Well Name: WF FEDERAL 28	Well Location: T30N / R14W / SEC 28 / NWSE / 36.78212 / -108.311902	County or Parish/State: SAN JUAN / NM
Well Number: 2	Type of Well: CONVENTIONAL GAS WELL	Allottee or Tribe Name:
Lease Number: NMNM97843	Unit or CA Name:	Unit or CA Number:
US Well Number: 3004529948	Well Status: Gas Well Shut In	Operator: HILCORP ENERGY COMPANY

Sundry ID: 2653651
Type of Submission: Notice of Intent
Date Sundry Submitted: 01/21/2022
Date proposed operation will begin: 02/01/2022
Type of Action: Plug and Abandonment
Time Sundry Submitted: 09:24

P&A Procedure

CONDITIONS OF APPROVAL

PROPOSED P&A WELLBORE SCHEMATIC

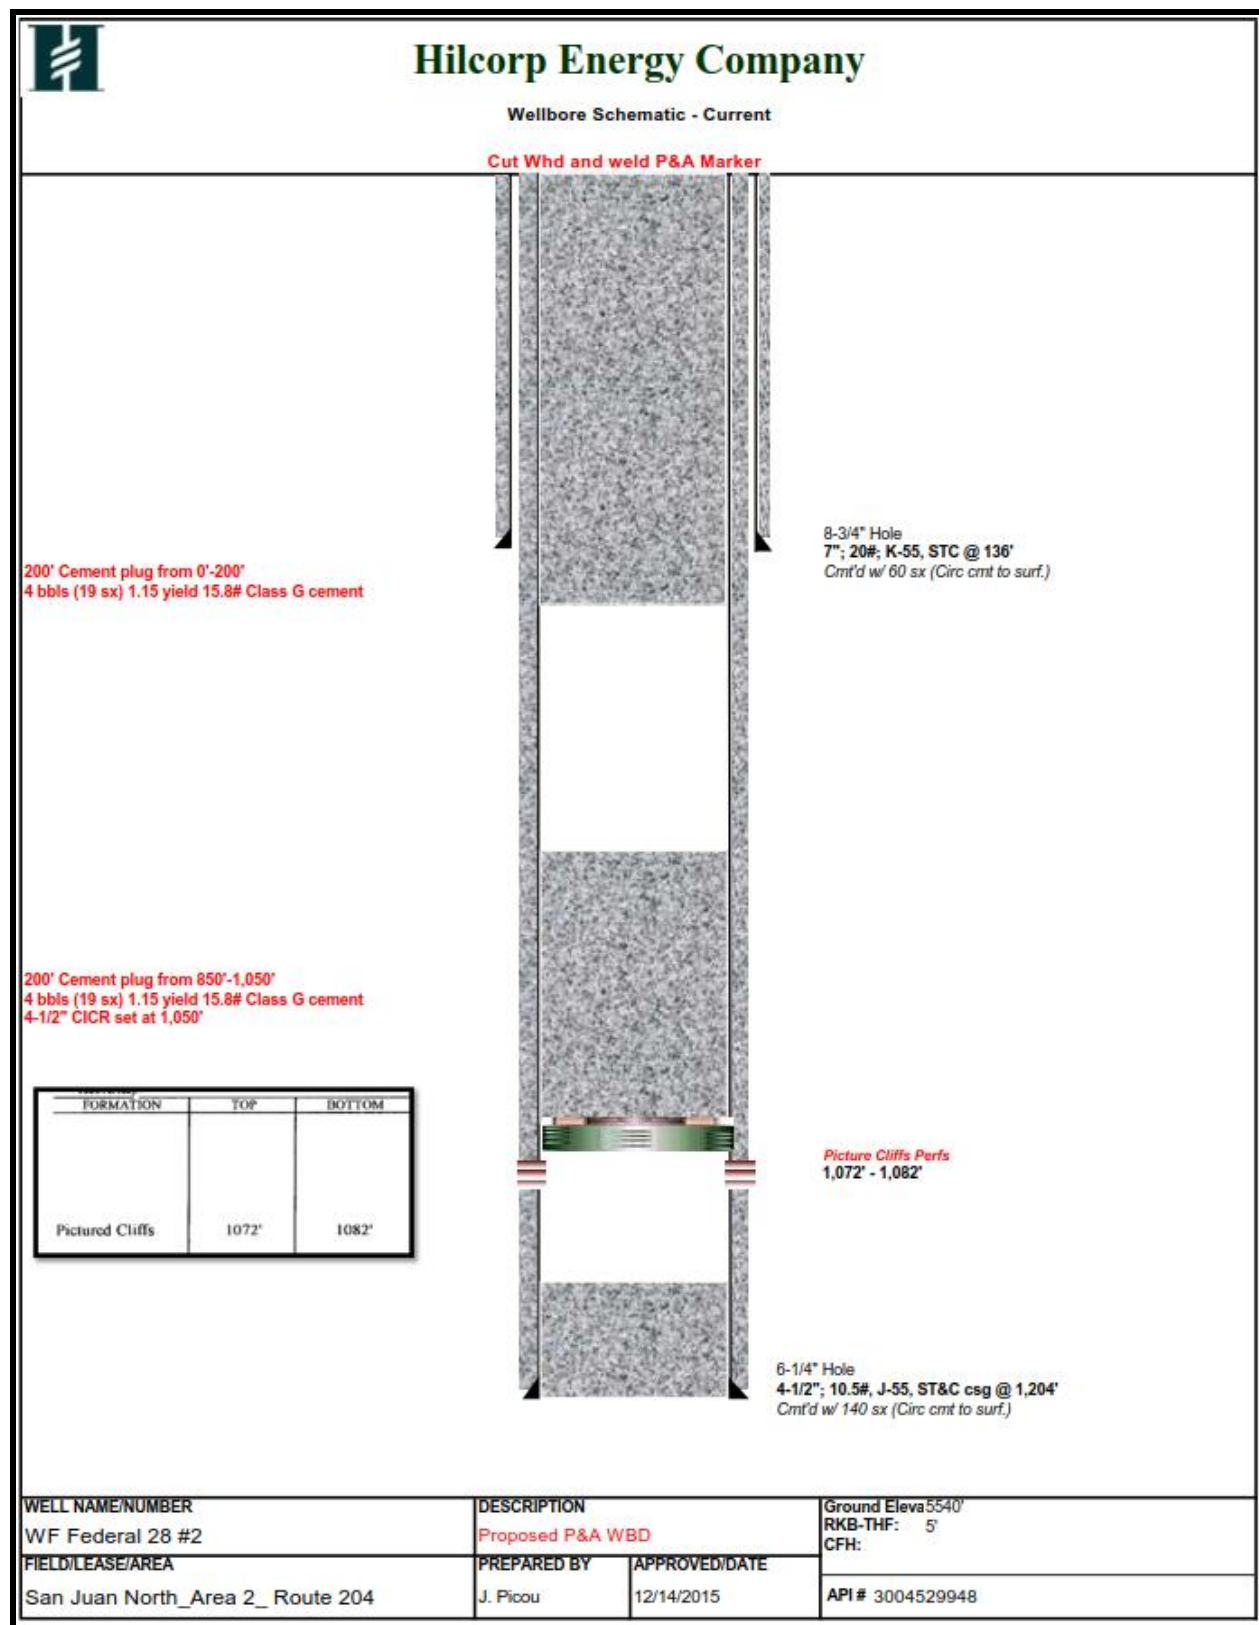
1. Plugging operations authorized are subject to the attached "General Requirements for Permanent Abandonment of Wells on Federal and Indian Lease."
2. The following modifications to your plugging program are to be made:
 - a) Plug 1 (Fruitland): Bring the top of the plug up to 770 feet to cover BLM pick for the Fruitland formation top.
3. Farmington Office is to be notified at least 24 hours before the plugging operations commence at (505) 564-7750.

- Bring the top of Plug #1 up to 770' to cover BLM pick for the Fruitland formation top.
- The plugs proposed in the P&A procedure, with recommended changes, will adequately protect any freshwater sands in this well bore.
- Pictured Cliffs perfs 1072' – 1082'.
- Note: H₂S has not been reported in this well but has been reported in wells to the north and west at concentrations up to 1000 PPM.
